Addendum #2

Date	Owner Property Number	Owner Building Number	BHDA Project Number
Fri, 22 Jun 2018	505-1975	Orem UT South FM Group Building #20	1822

Project Designation	Project Address
Cherry Hill 1, 2, 4 Mother's Room Orem UT Cherry Hill Stake	1700 South 400 East Orem, Utah 84058

SHEET TITLE: DEMOLITION REFLECTED CEILING PLAN AND REFLECTED CEILING PLAN

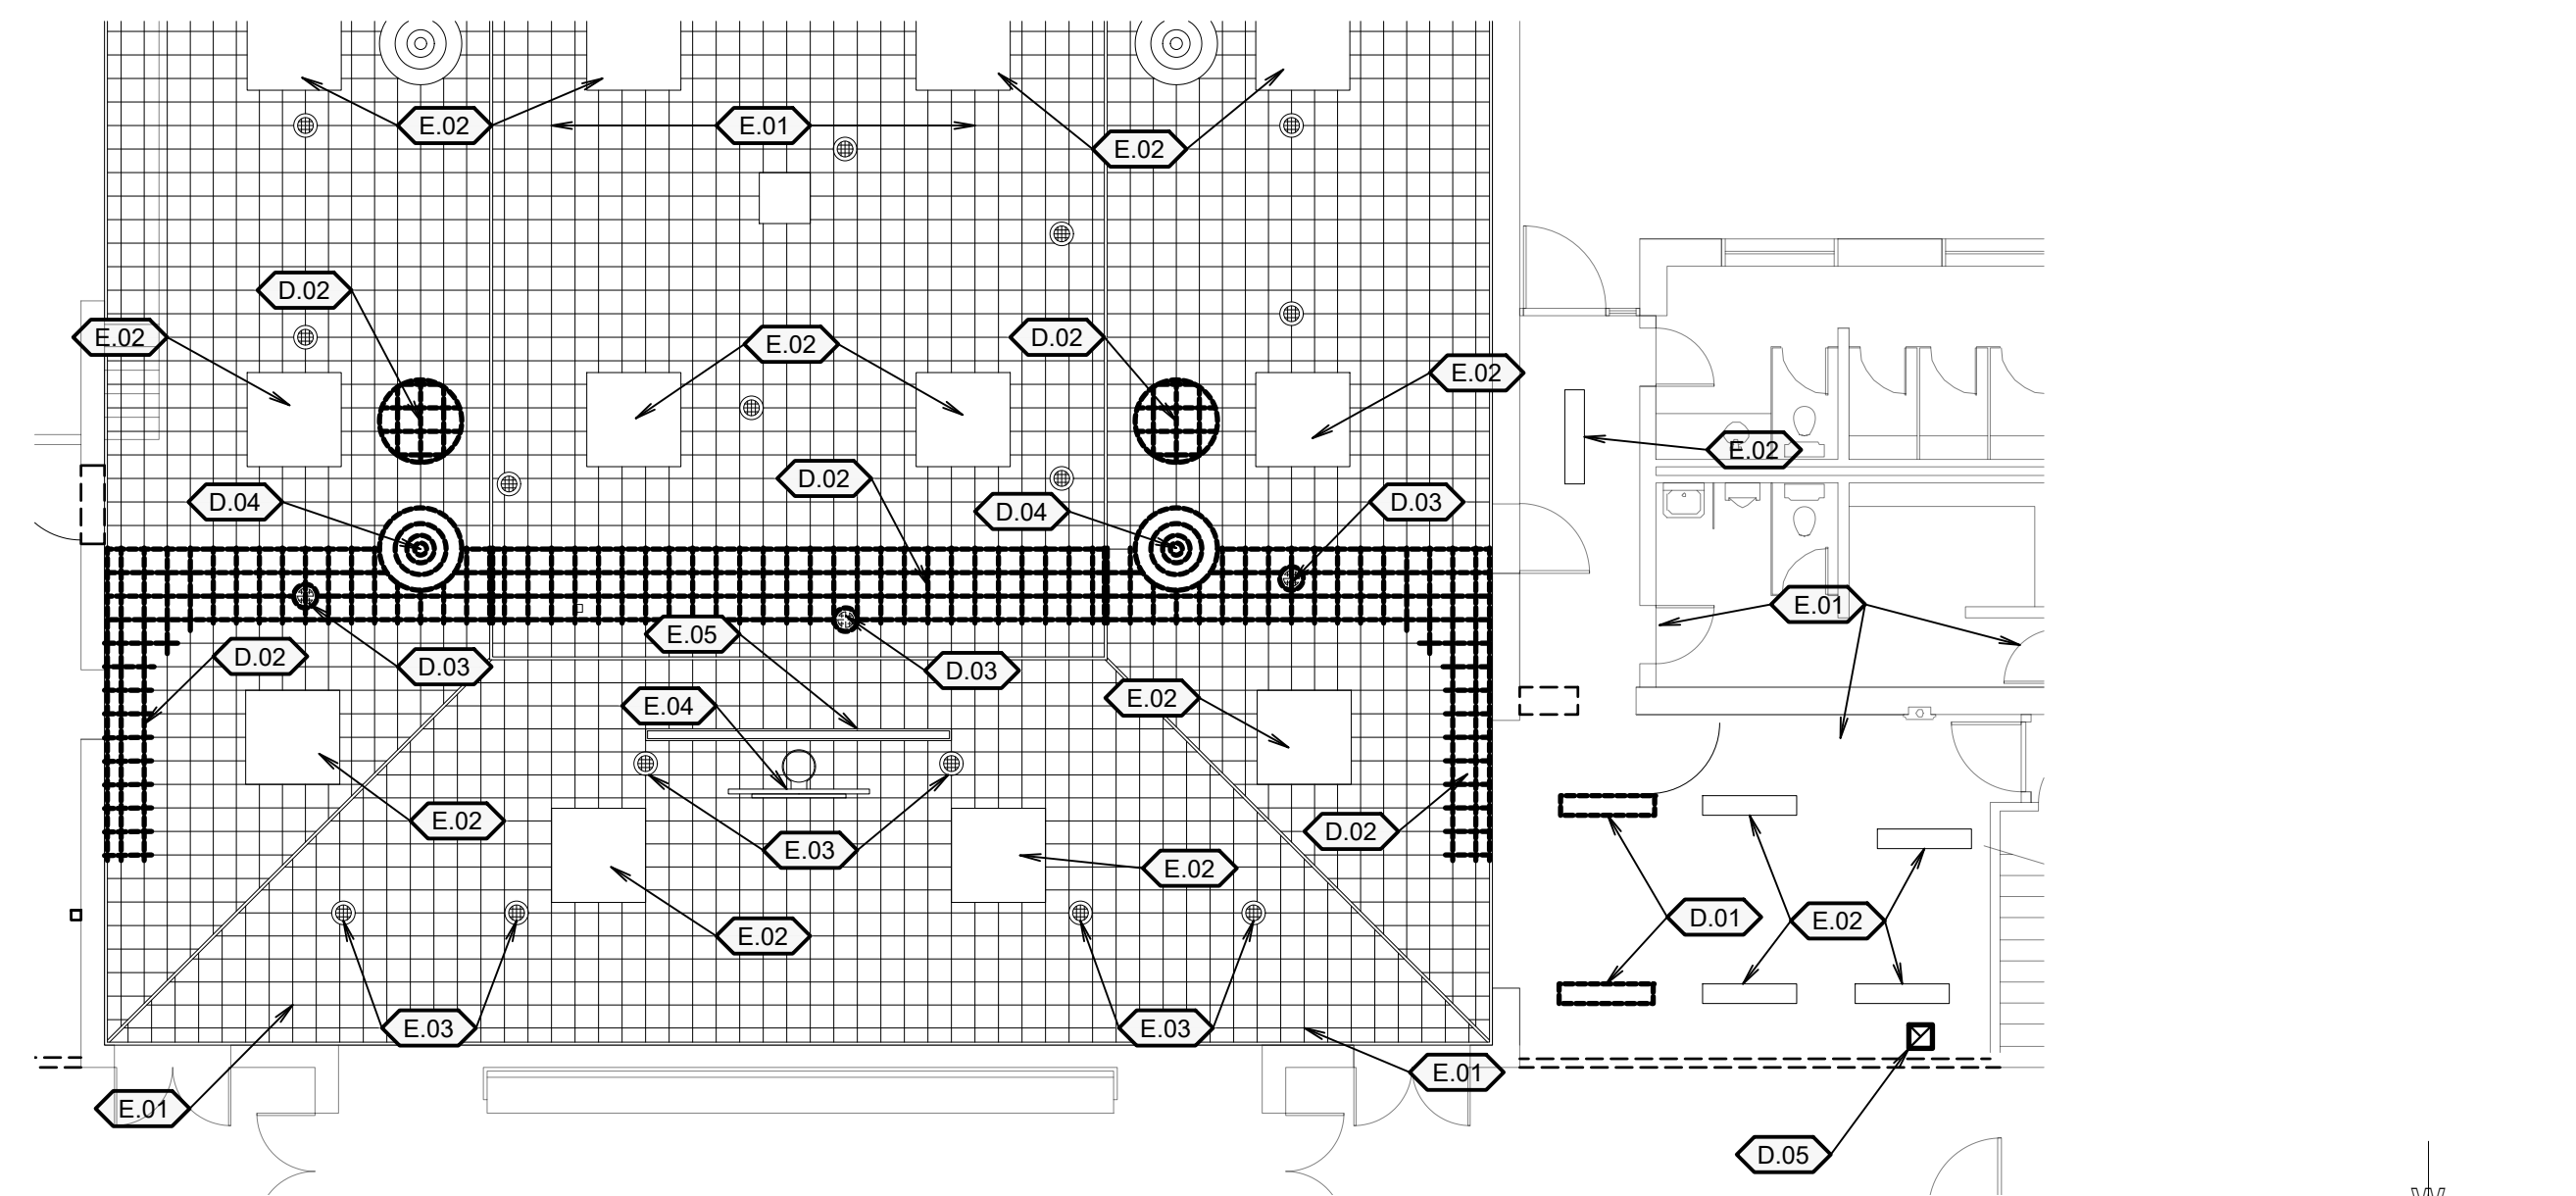
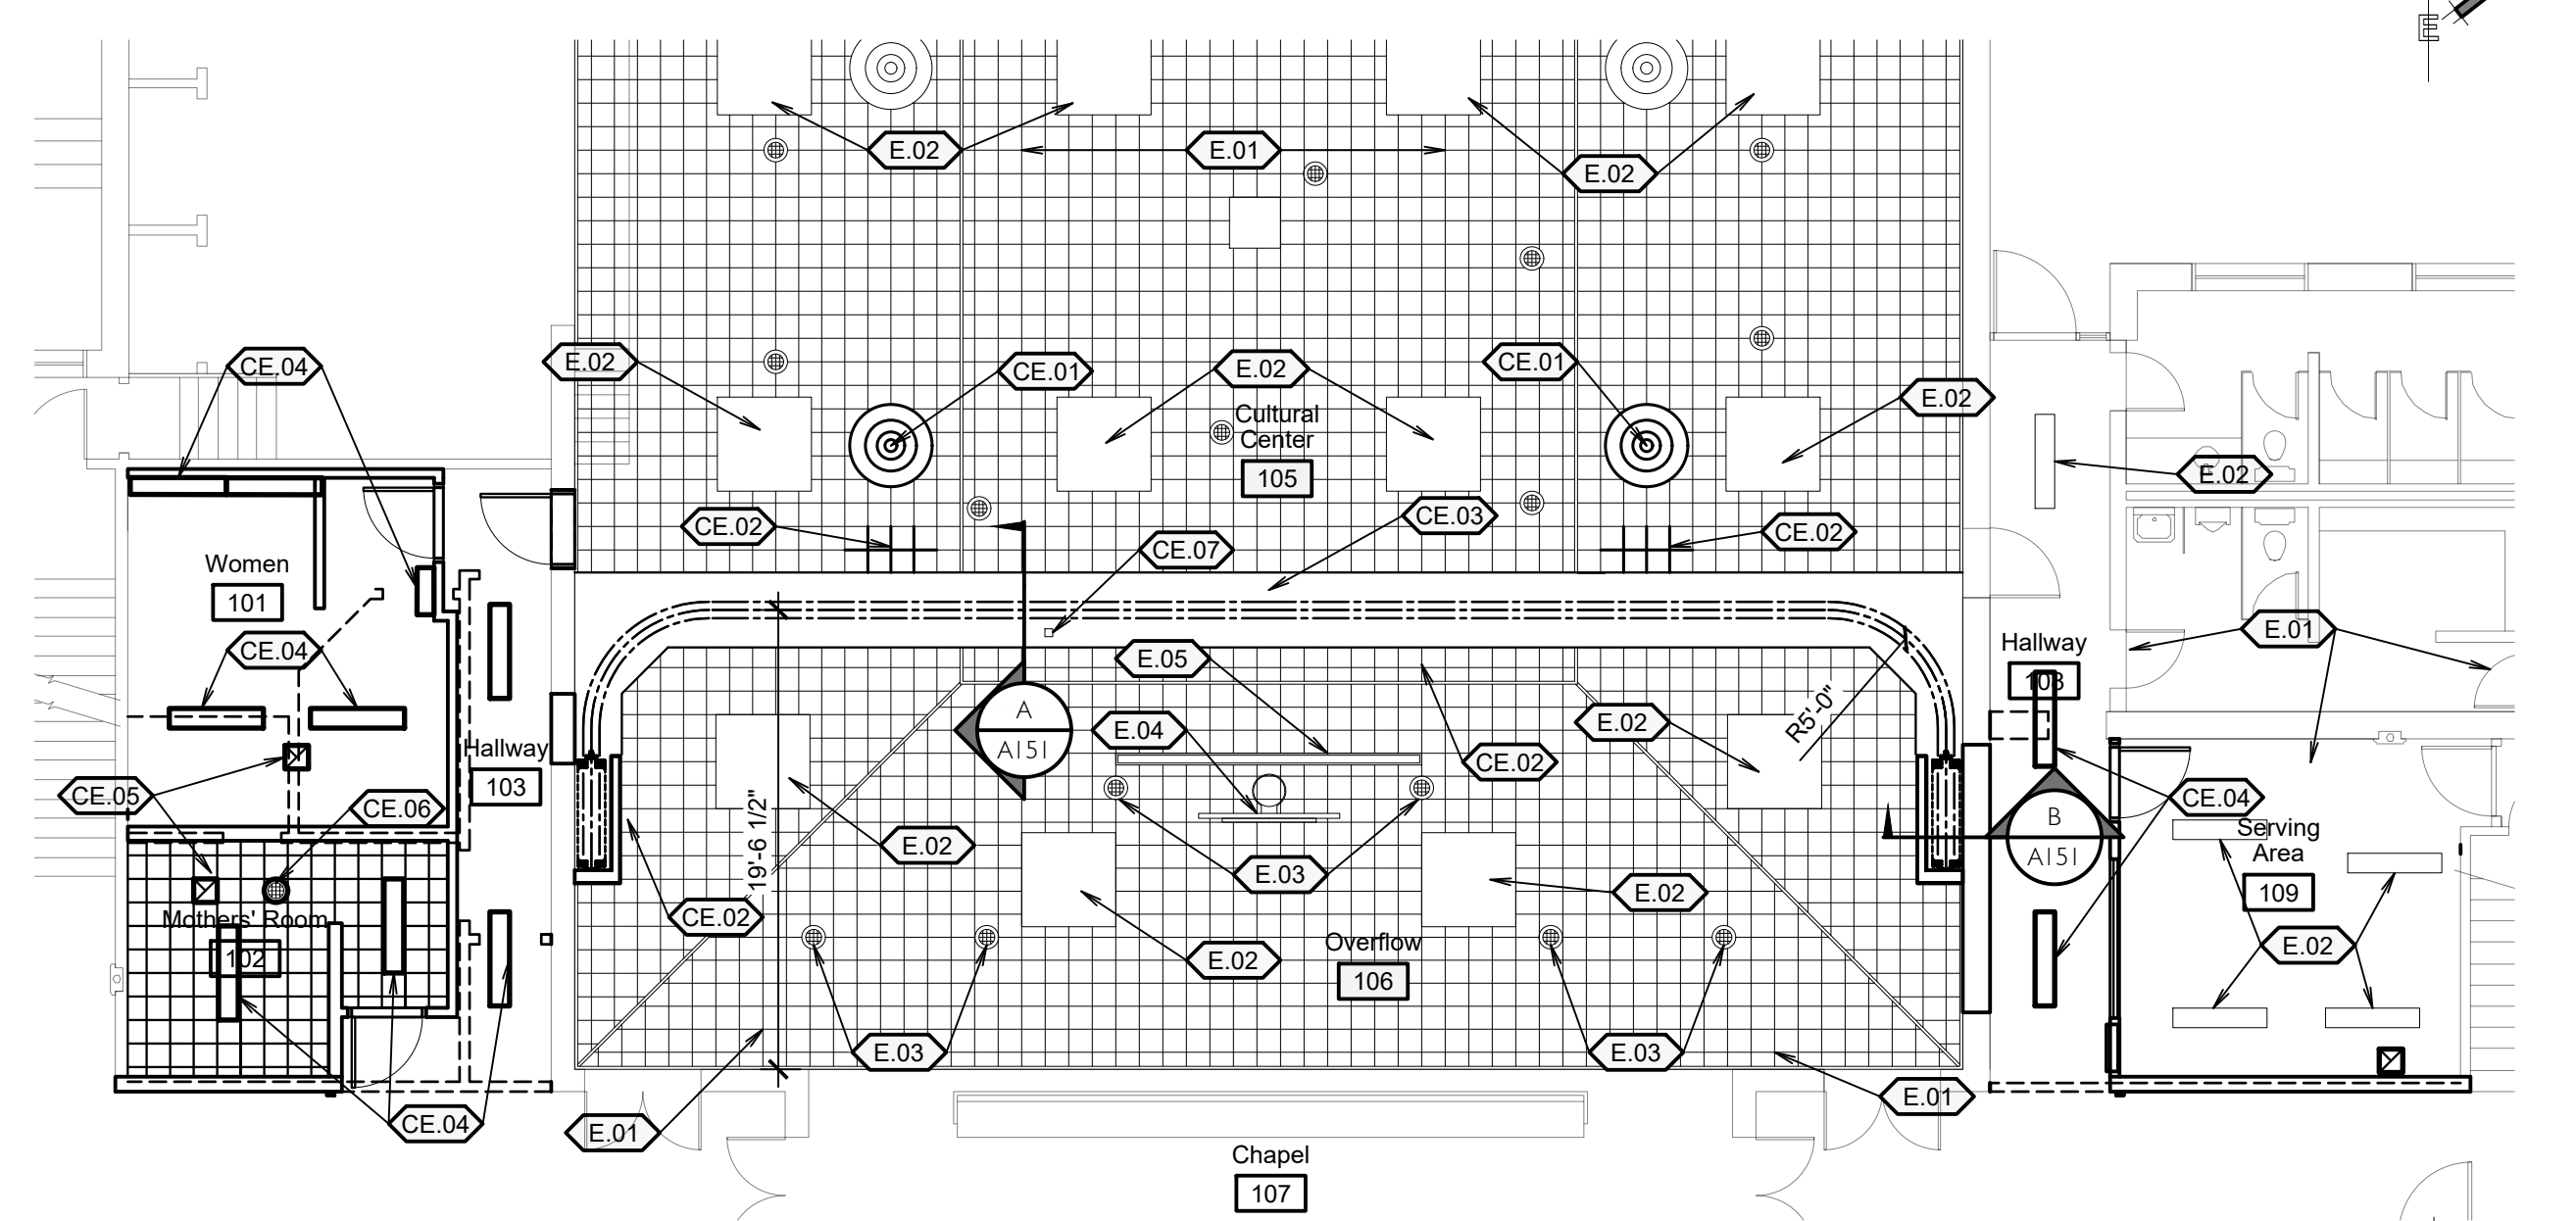
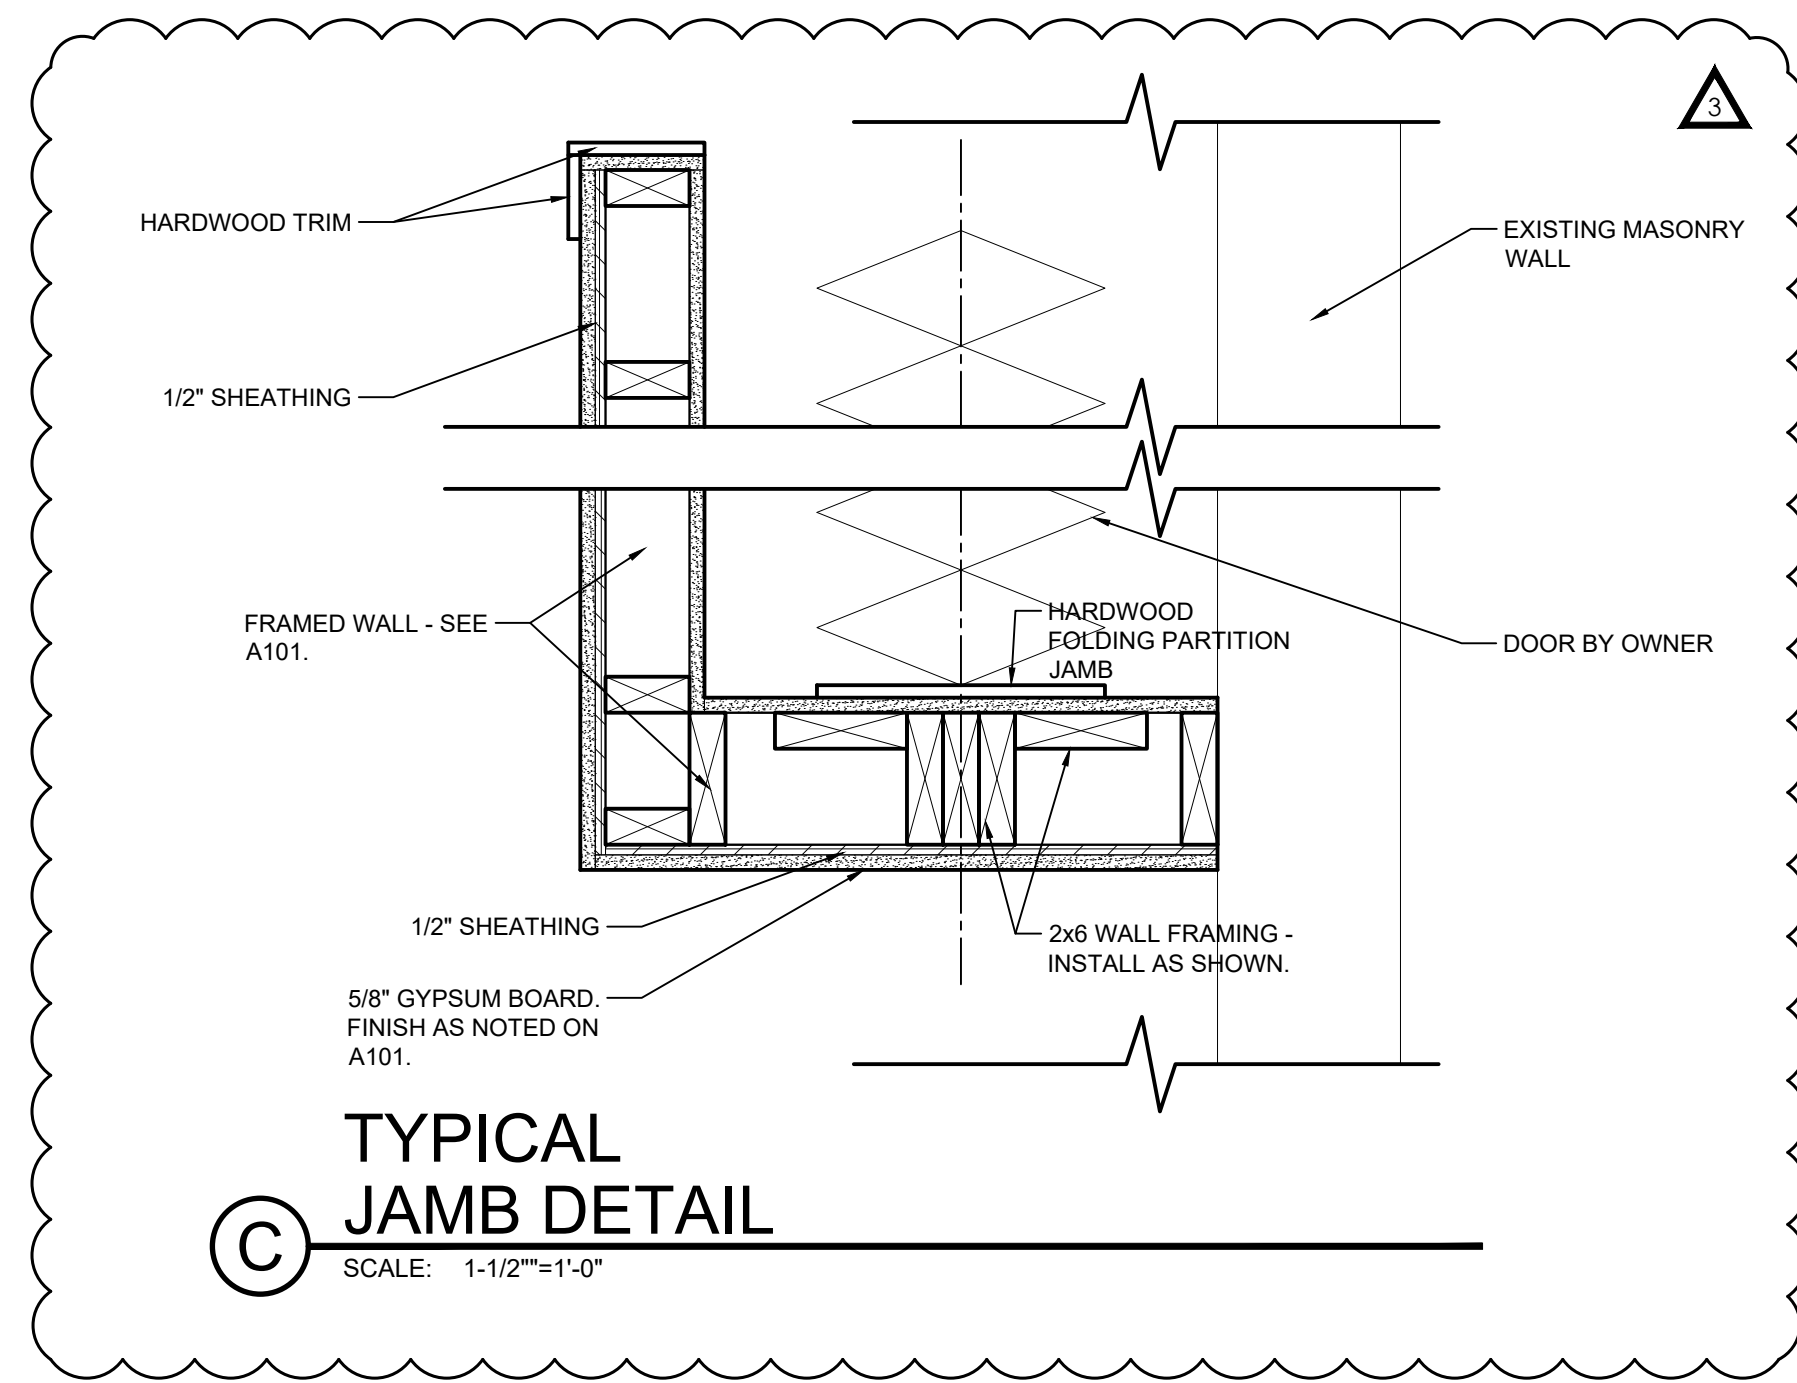
4.01. Sheet A151 Demolition Reflected Ceiling Plan and Reflected Ceiling Plan

- A. Replace this Sheet with the attached revised Sheet.
- B. Add Jamb Detail for the Accordion Partition.
